CHANGE REQUEST

⌘ **24.008 CR 390** ⌘ rev **1** ⌘ Current version: **3.6.0** ⌘

Title:	⌘ Equivalent handling of PLMNs with different PLMN codes		
Source:	⌘ Motorola, Telia, Vodafone		
Work item code:	⌘ GSM-UMTS INTERWORKING	Date:	⌘ 5 March 2001
Category:	⌘ F	Release:	⌘ R99
	<i>Use <u>one</u> of the following categories:</i> F (essential correction) A (corresponds to a correction in an earlier release) B (Addition of feature), C (Functional modification of feature) D (Editorial modification) Detailed explanations of the above categories can be found in 3GPP TR 21.900.		<i>Use <u>one</u> of the following releases:</i> 2 (GSM Phase 2) R96 (Release 1996) R97 (Release 1997) R98 (Release 1998) R99 (Release 1999) REL-4 (Release 4) REL-5 (Release 5)

Figure 10.5.z/3GPP TS 24.008 *PLMN List* information element

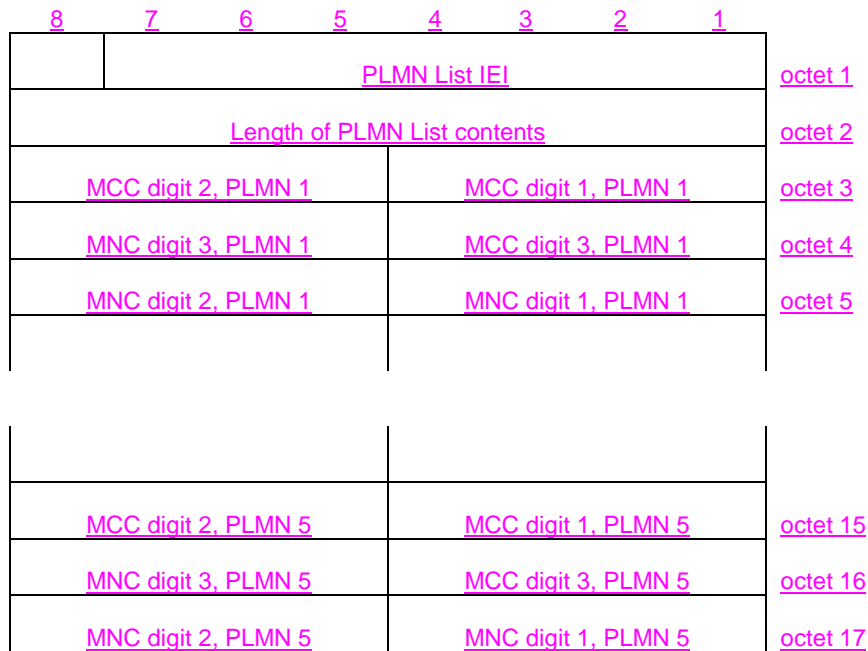
The purpose of the *PLMN List* information element is to provide a list of PLMN codes to the mobile station.

The *PLMN List* information element is coded as shown in figure 10.5.z/3GPP TS 24.008 and table 10.5.w/3GPP TS 24.008.

The *PLMN List* is a type 4 information element with a minimum length of 5 octets and a maximum length of 17 octets.
